Planning Commission Application

FORT GRATIOT PLANNING COMMISSION SITE PLAN REPORT

RE: Smart Storage Solutions - Mini Storage Site Plan, 3134 Keewahdin Road, Fort Gratiot Township (Plan Review No. 01)

SITE PLAN
SMART STORAGE SOLUTIONS
3134 KEEWAHDIN ROAD, FORT GRATIOT, MI 48059

GENERAL STORM SEWER NOTES

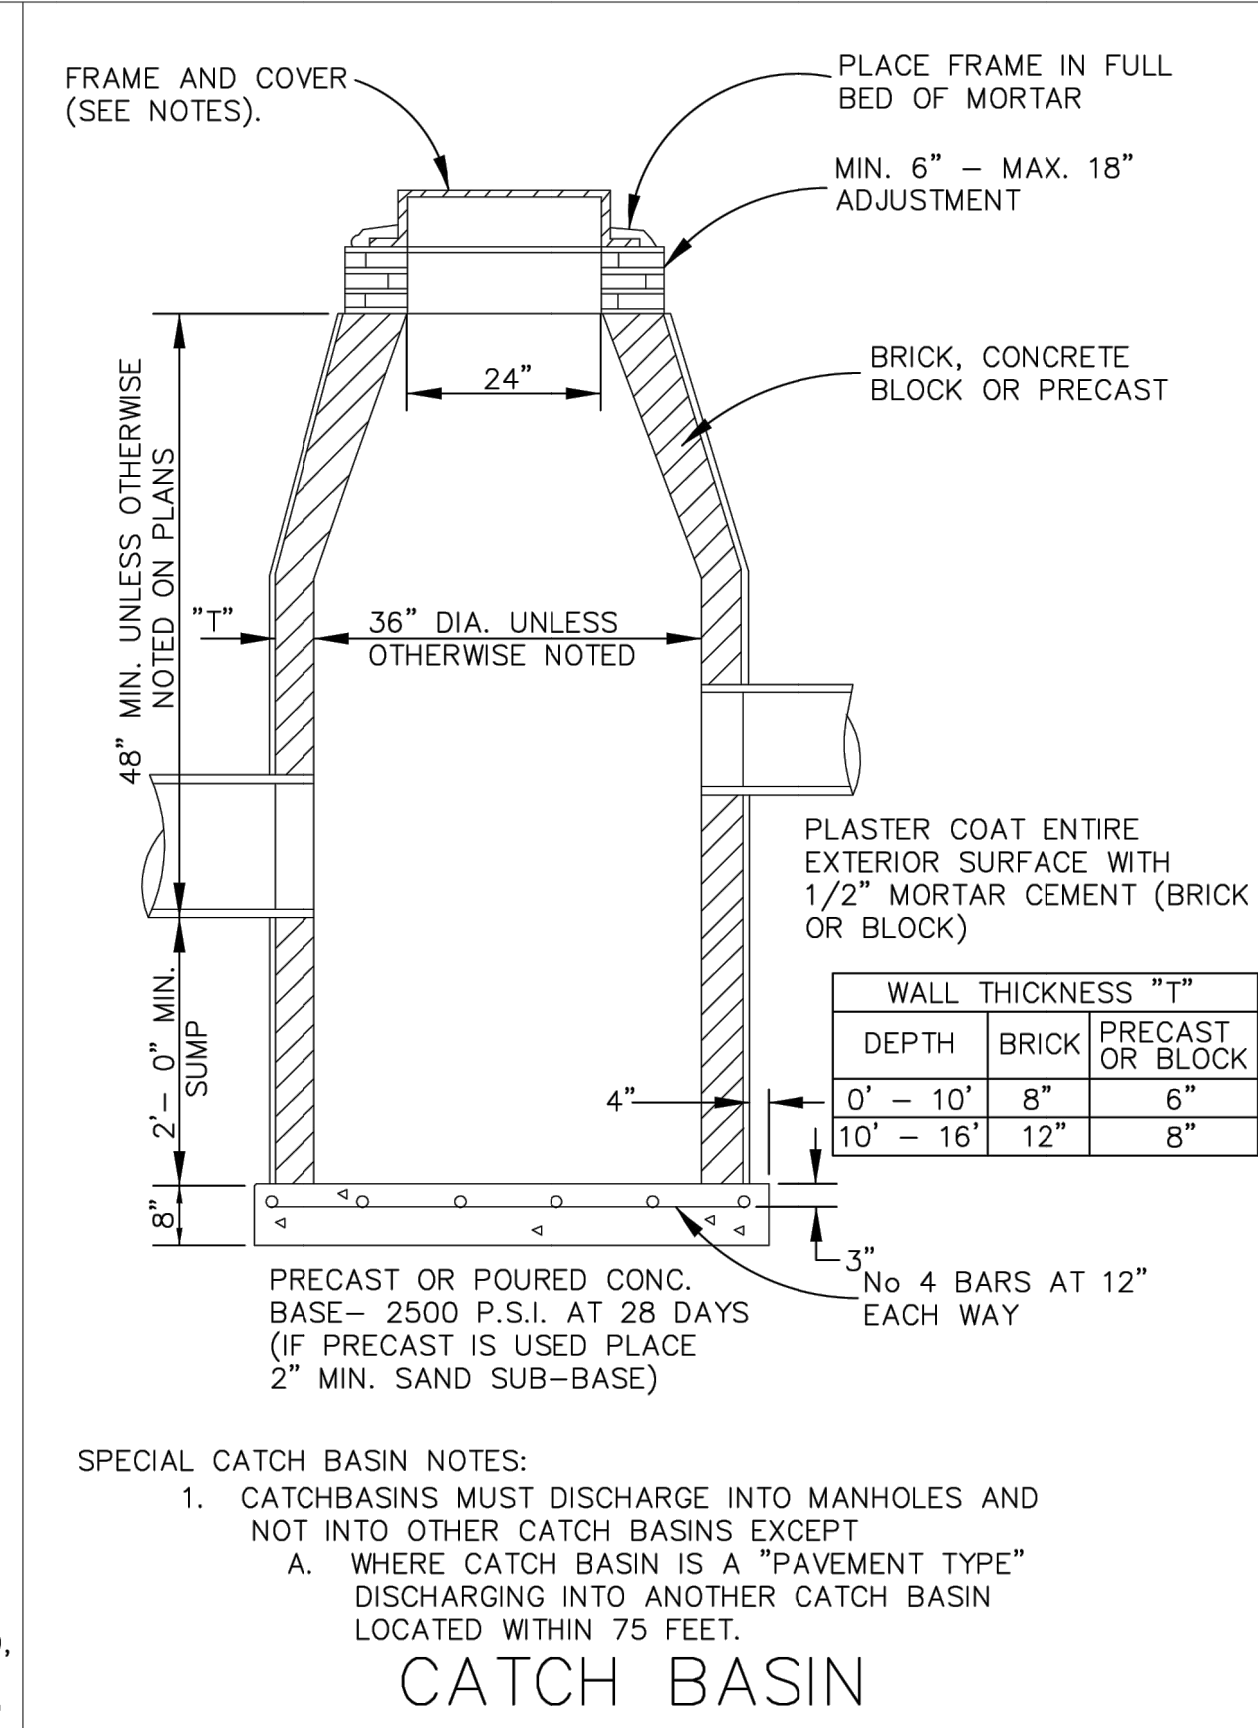
5. The Permanent Detention Basin Outlet Filter Detail on Sheet 5 indicates eight 1-inch outlet holes are to be provided at elevation 601.00 for the 100-year outlet. These holes are not shown in the detail drawing and should be provided.
